Access Compliance Report

Public Rights-of-Way

(Curb Ramps)

Intersection ID: 28144	Main Street: DONNINGTON_DR	Cross Street: FULLER_PL	Location:	N
ADA ID: 838620366A14	Ramp Type: PerpDiag	Initial Pass/Fail: Fail	Overall Compliance: No	Severity Score: 37.5
Codes/Mitigation Info/Possible Solution		Field Measurements/Component Compliance

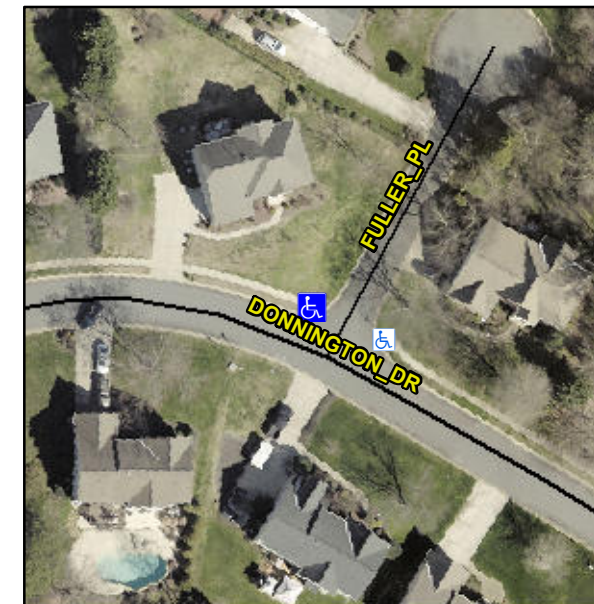
Not Found, R304.2.2, R304.5.3

Compliance	Description	Data	Compliance	Description	Data
N/A	Ramp Length (in)	100.0	No	Ramp Slope (%)	11.2
Yes	Ramp Width (in)	99.0	No	Ramp XSlope (%)	10.8
N/A	Flare Type LT	N/A	N/A	Flare Type RT	N/A
N/A	Flare Slope LT (%)	N/A	N/A	Flare Slope RT (%)	N/A
N/A	Flare Traversable LT?	N/A	N/A	Flare Traversable RT?	N/A
N/A	Landing Length (in)	N/A	N/A	DWS Provided?	N/A
N/A	Landing Width (in)	N/A	N/A	DWS Contrast?	N/A
N/A	Landing Slope (%)	N/A	N/A	DWS Length (in)	N/A
N/A	Landing X Slope (%)	N/A	N/A	DWS Full Width?	N/A
N/A	Landing Curb? (Y/N)	N/A	N/A	DWS Offset (in)	N/A
N/A	Shared Landing?	N/A			
N/A	Gutter Ponding?	N/A	N/A	Gutter Slope (%)	N/A
N/A	Gutter Lip Ht (in)	N/A	N/A	Gutter X Slope (%)	N/A
N/A	Painted X Walk1?	No	N/A	Painted X Walk2?	No
	X Walk 1 Direction	To SW		X Walk 2 Direction	To SE
N/A	X Walk 1 Width (in)	N/A	N/A	X Walk 2 Width (in)	N/A
	X Walk 1 Slope (%)	9.4		X Walk 2 Slope (%)	3.8
	X Walk 1 X Slope (%)	5.9		X Walk 2 X Slope (%)	7.6

Remove & Replace Curb Ramp With Two New Directional Ramps or Equivalent.
